14. DESCRIPTION OF AMENDMENT/MODIFICATION (Organized by UCF section headings, including solicitation/contract subject matter where feasible.) AMENDMENT 0005 TO RENOVATION OF BUP BARRACKS, BUILDINGS 860, 861 AND 862, FORT STORY, VIRGINIA. Due date for receipt of proposals for subject solicitation is rescheduled to: February 14, 2002 at 2:00 p.m.							
Except as provided herein, all terms and conditions of the document referenced in Item 9A or 10A, as heretofore changed, remains unchanged and in full force and effect.							
15A. NAME AND TITLE OF SIGNER (Type or print)				16A. NAME AND TITLE OF CONTRACTING OFFICER (Type or print)			
15B. CONTRACTOR/OFFEROR		15C. DATE SIGNED		16B. UNITED STATES OF AMERICA		16C. DATE SIGNED	
_____ (Signature of person authorized to sign)				BY _____ (Signature of Contracting Officer)		08-Feb-2002

**BARRACKS COMPLEX
FORT STORY
VIRGINIA BEACH, VIRGINIA**

MECHANICAL FLOOR PLANS
MODIFICATIONS TO SHT M2.01

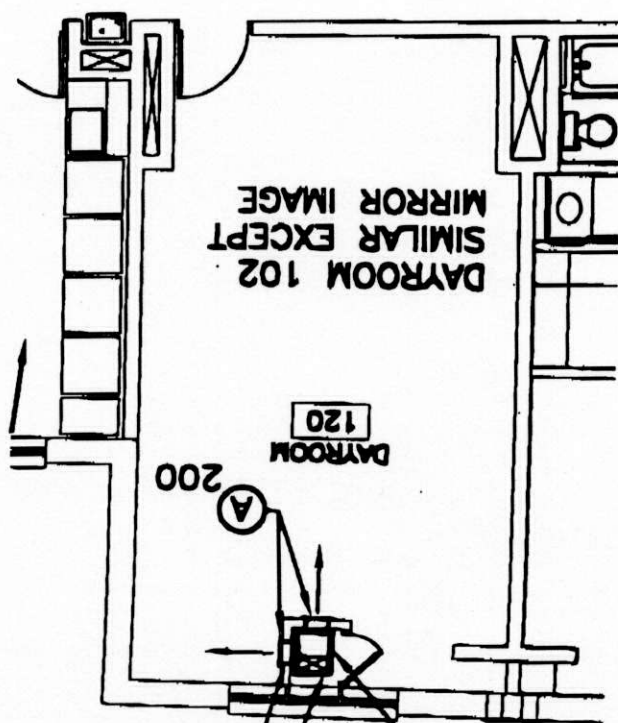
On Dwg. 721-12-28(M2.01)

At Dayroom 102 and Dayroom 120 provide ductwork and diffusers as shown on the attached sketch SKM201-1.
